ATTACHMENT 8

RE: File# 2015-7686
Address: 830 East El Camino Real, Sunnyvale (APN: 211-25-046)
Project: Hilton Homewood Gardens

Re: File 2015-7686
830 E. El Camino Real, Sunnyvale
APN 211-25-046
Hilton Homewood Gardens Project

RE: File# 2015-7686
Address: 830 East El Camino Real, Sunnyvale (APN: 211-25-046)
Project: Hilton Homewood Gardens

② Section 1
1/16" = 1'-0"

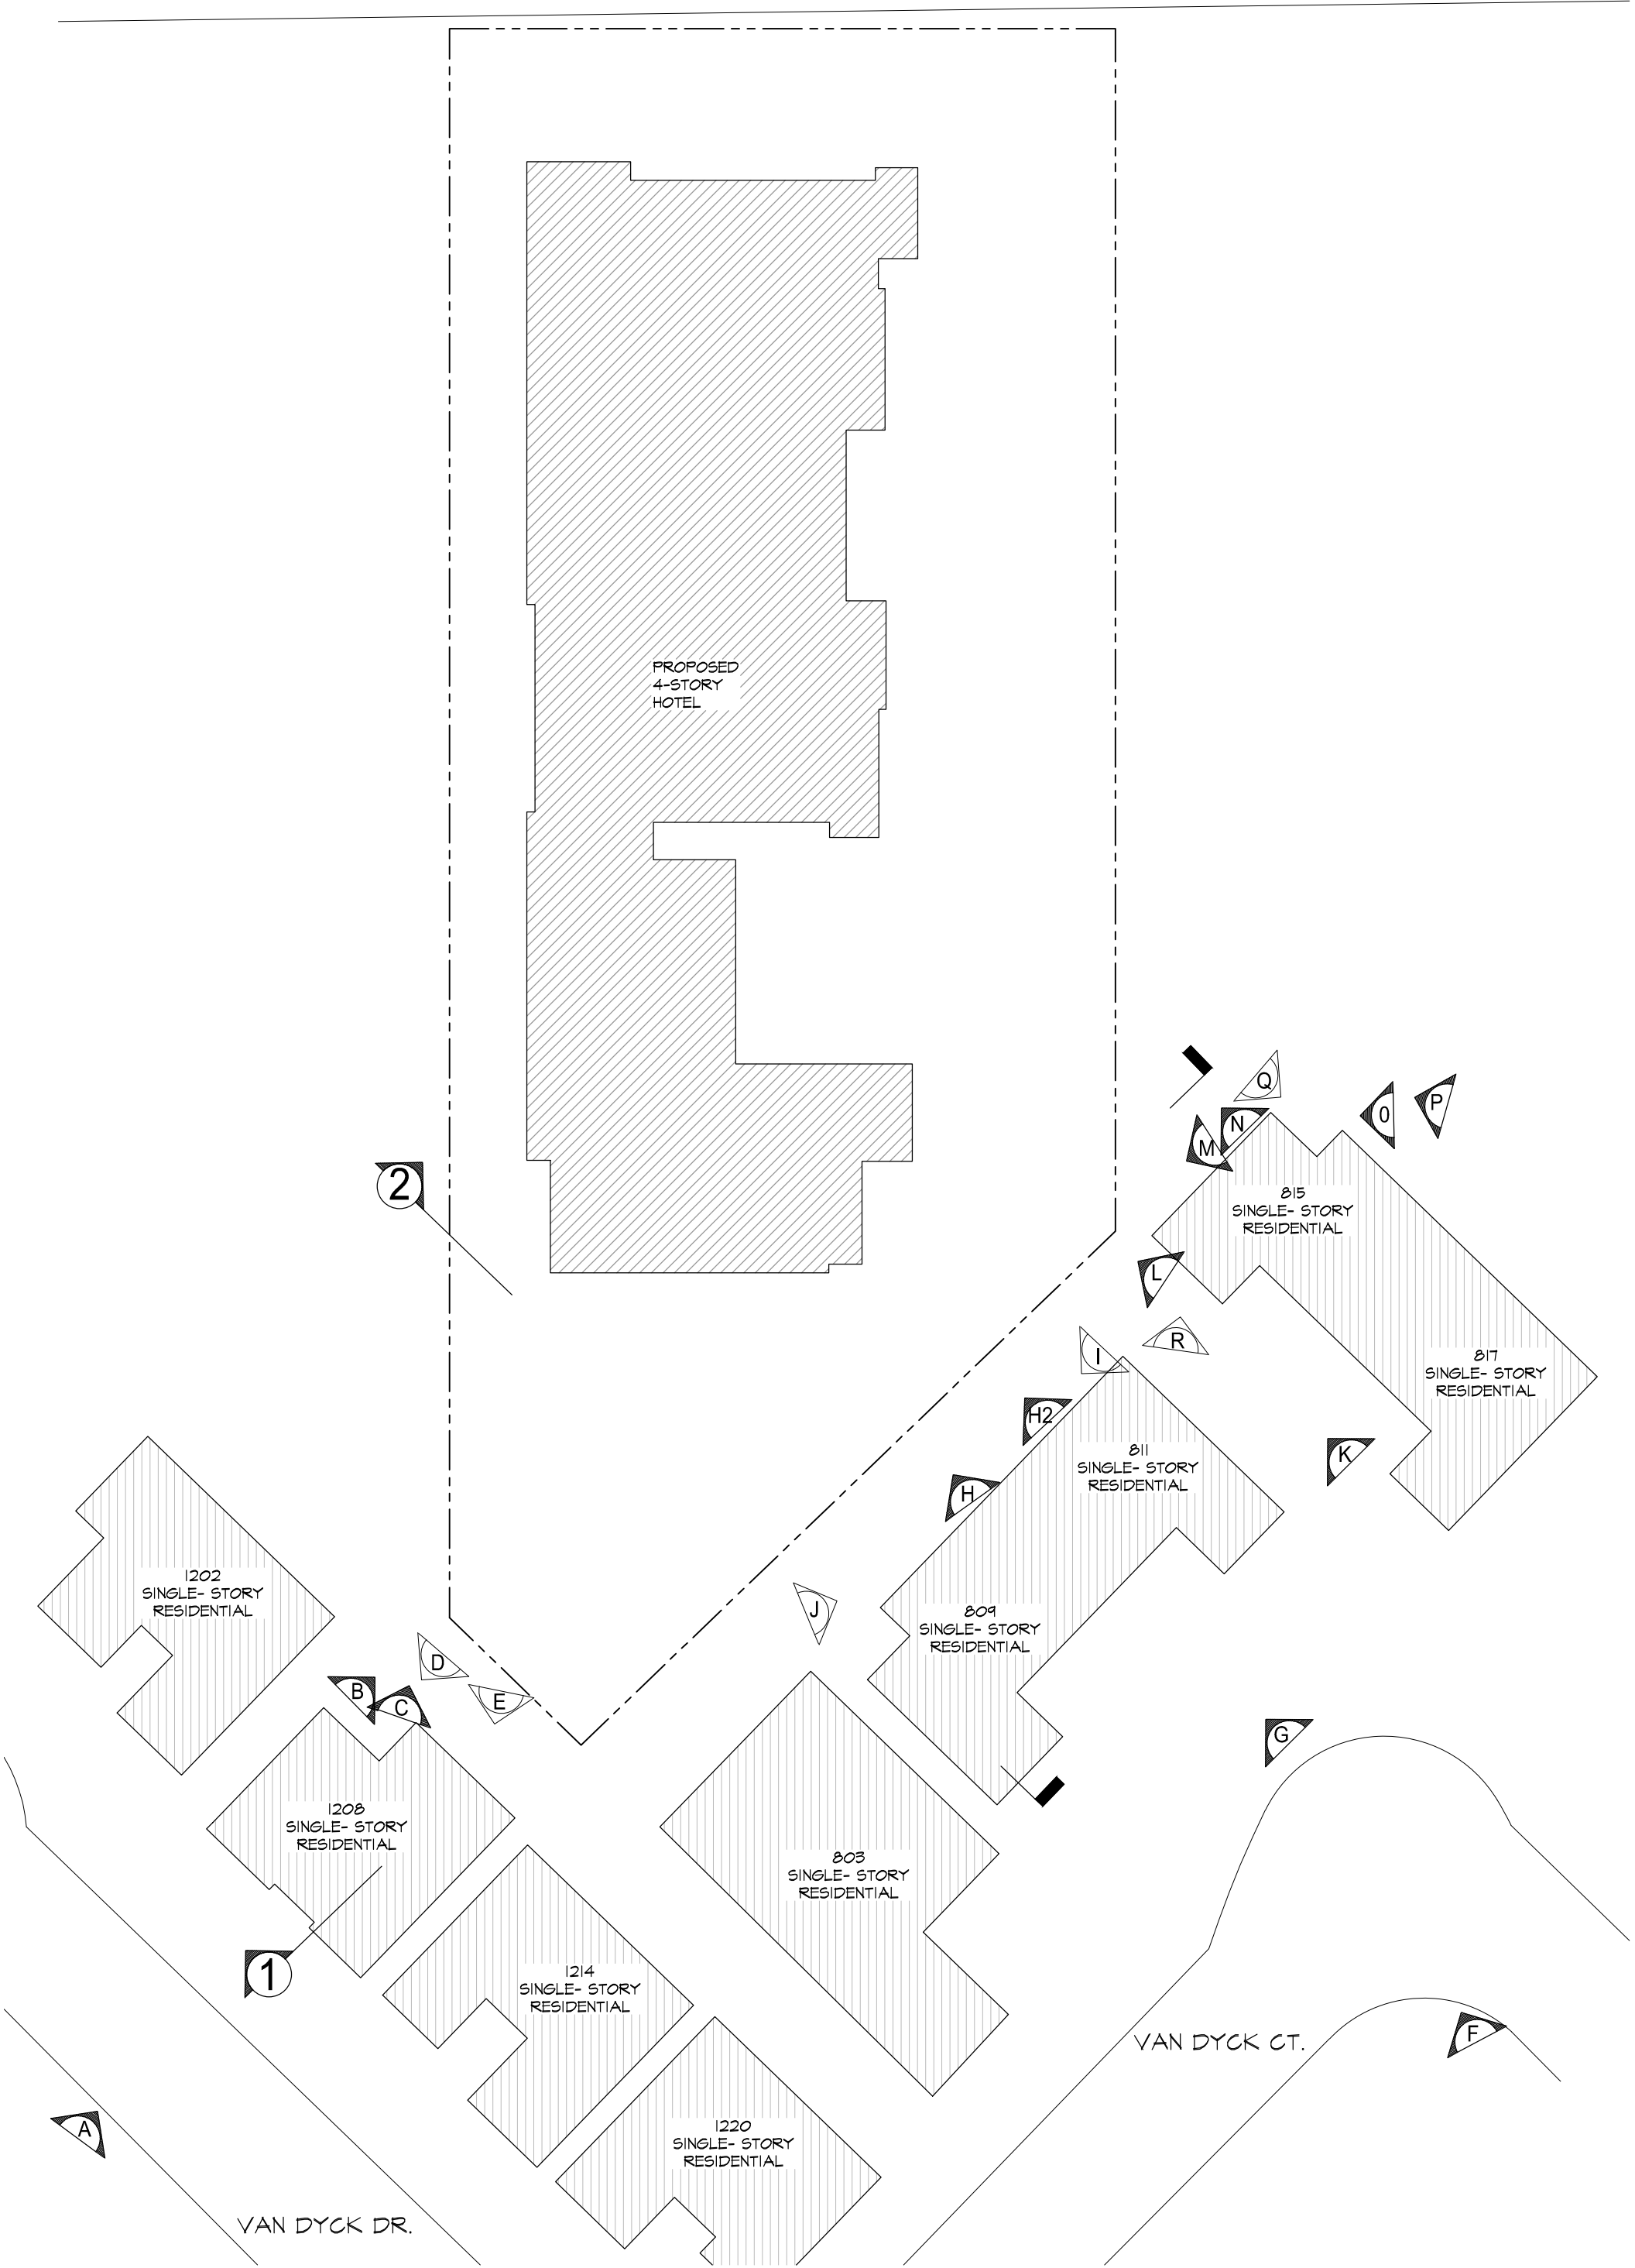
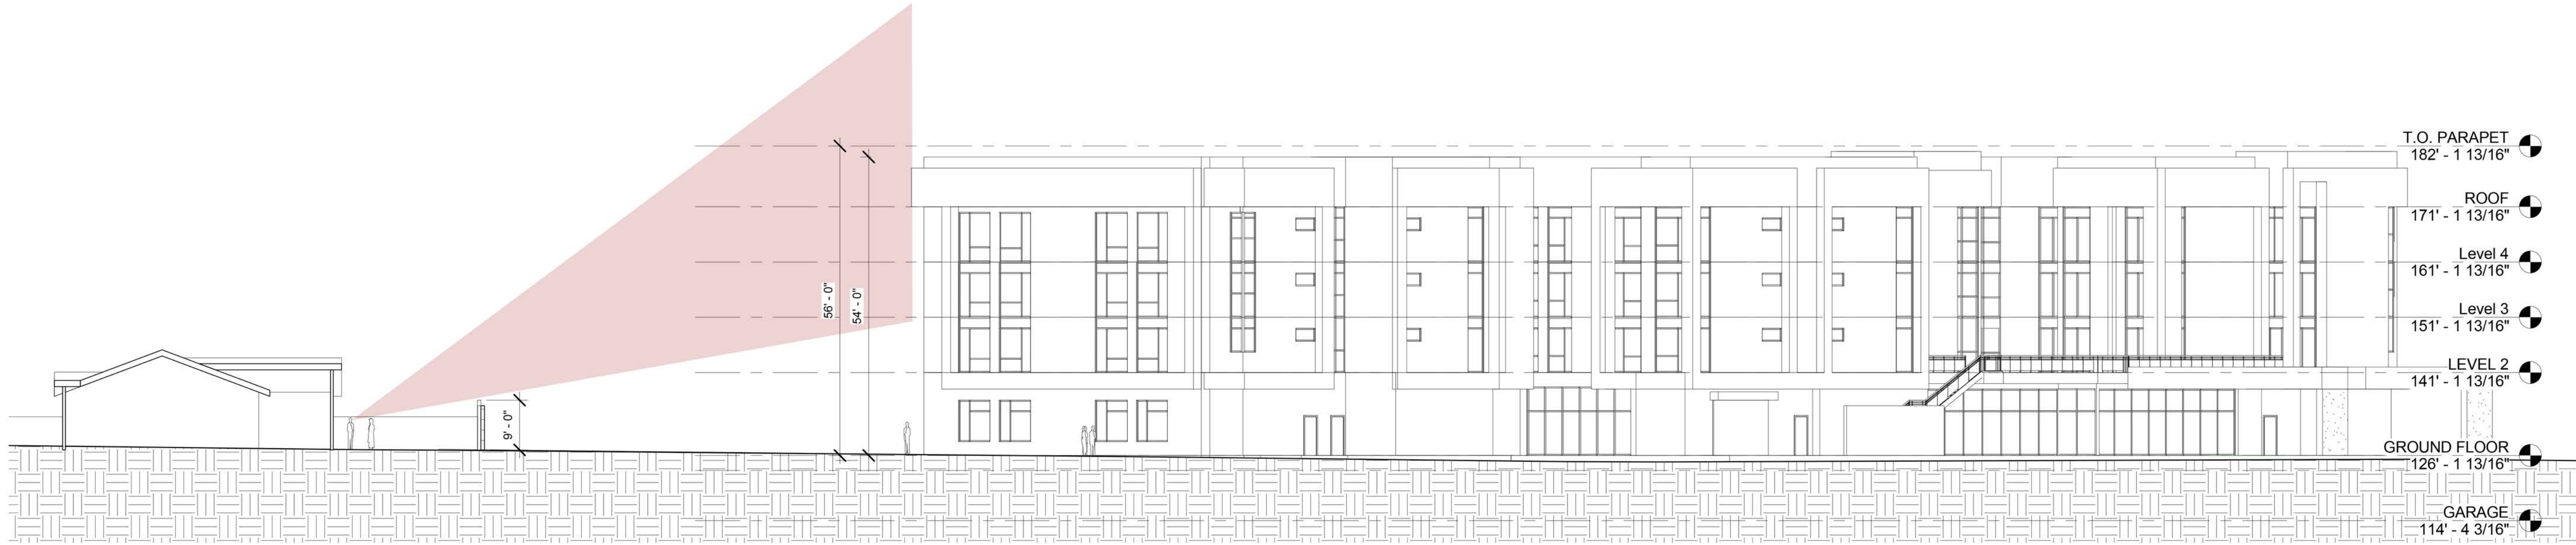
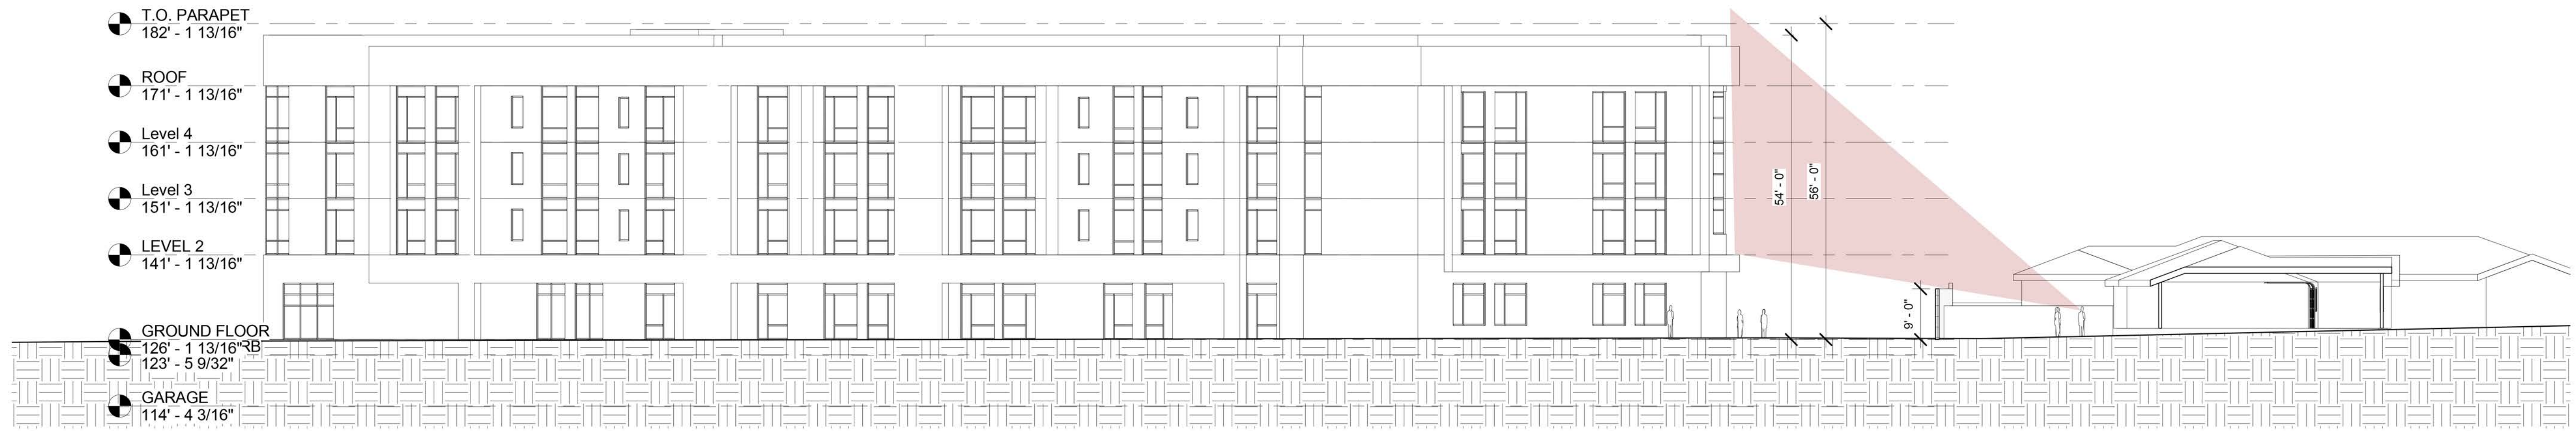
Submitted herewith are architectural models and a "Mass Study" prepared by Ray Viotti of Viotti Architects, 1300 Industrial Rd. Suite 14, San Carlos, CA 94070. The study clearly shows how massive the proposed project is as viewed from the properties of the residential neighbors. One neighbor is a single family residence, requiring 75' of setback, while the other

1) **Lower Building Height:** The hotel building is proposed at 4-stories high for all buildings, a total of 58'-8" high. The recommendation would be that the end tower building, containing 4 units on the planned south side of the structure and the building containing 1 king-studio on each floor on the east side of the project closest to the multi-family dwellings be reduced from 4-stories to 2-stories for a total of 35-37' (the second floor is 27'-8" but with roof screening on top would total approximately 35-37' high).

See architectural study submitted herewith along with photographs
